## SERVICE LETTER # 40

Subject: Flap Placard

Airplanes Affected: All M-5 Models, 5000C, 6000C and 7000C series serial numbers through 5057C, 6204C and 7219C.

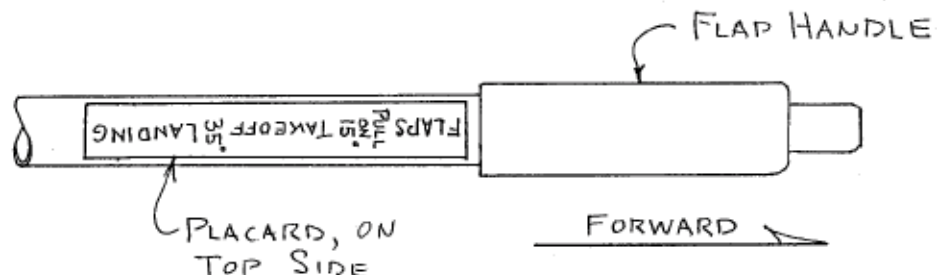
Background: A placard is required on the flap handle, and it is possible that this placard was left off of some of these airplanes.

If it does not have this placard, make sure the upper surface of the flap handle, just aft of the grip, is clean. Peel the backing from the placard and attach the placard to the flap handle as shown in the sketch.
